Specifically, in the testimony of Mr. Love on Terminal Blocks (Volume II of the Surrebuttal Testimony), at page 146, Mr. Love states that he has marked Figures 1 and 2 (the figures appear on pages 147 and 148, respectively) "to indicate each simulated DBA on the profiles." However, the Figures as they appear in the bound volume were not so marked. Attached are copies of the figures as they should have appeared, marked by Mr. Love.

Phase I Environmental Temperature Profile

Phase II Environmental Temperature Profile

Figure 1

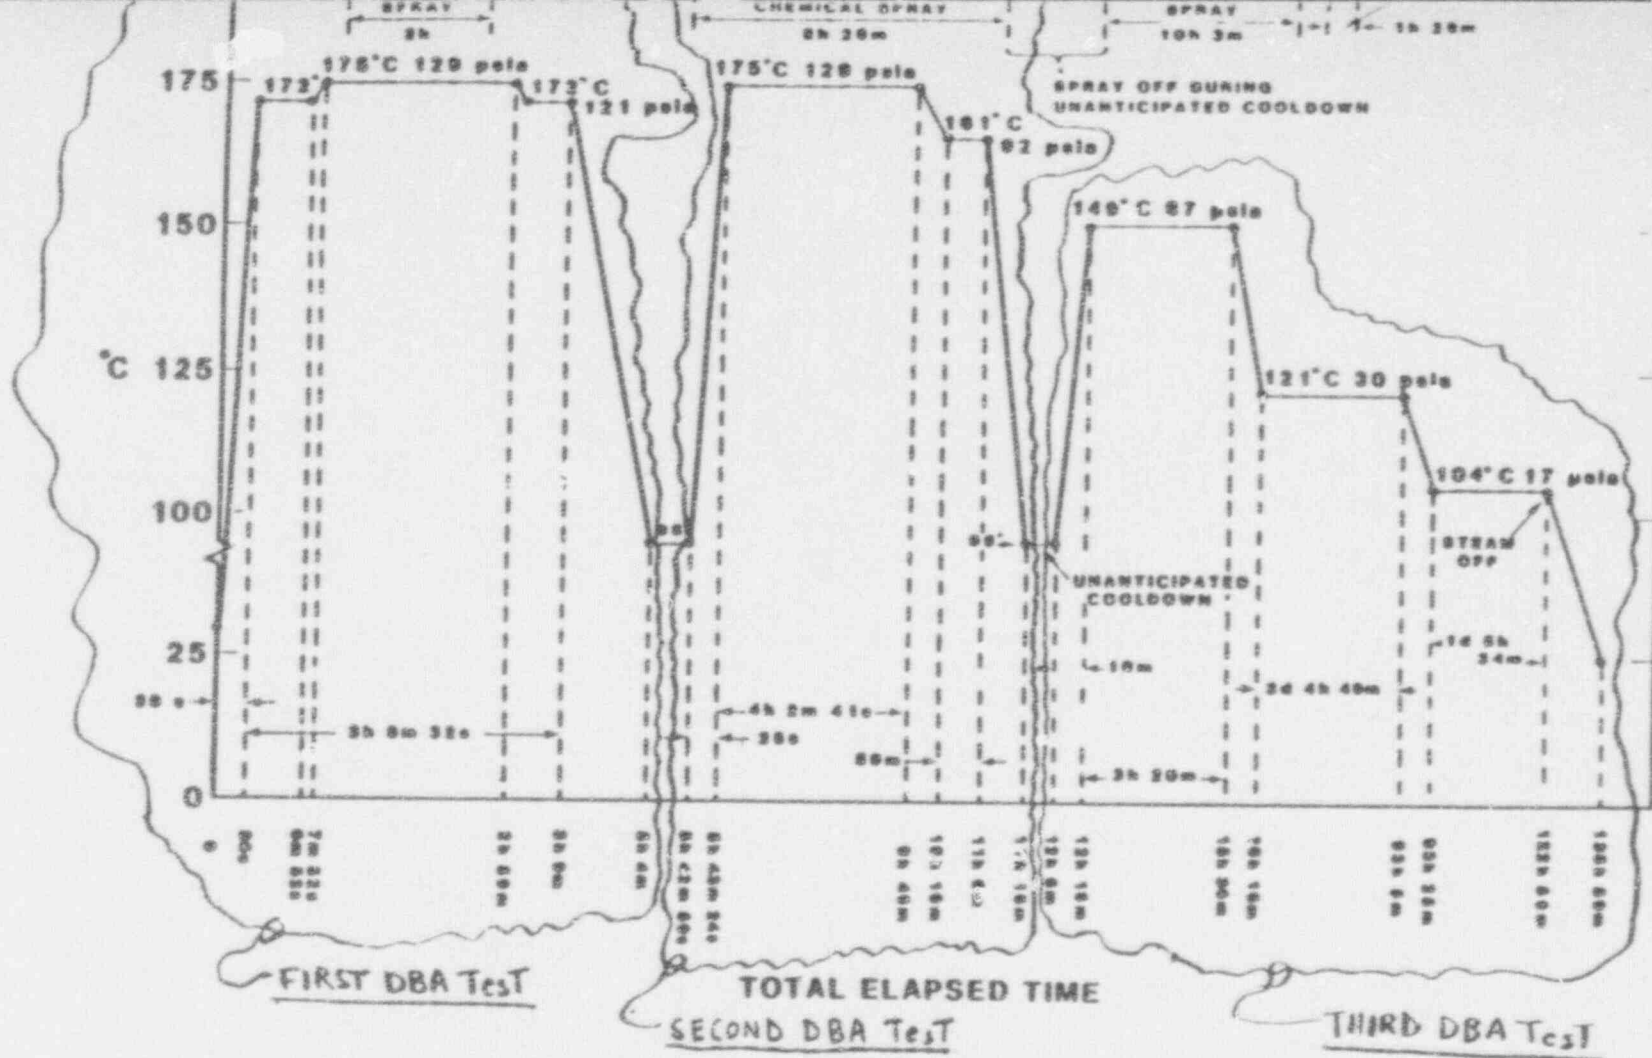
FIRST DBA Test

SECOND DBA Test
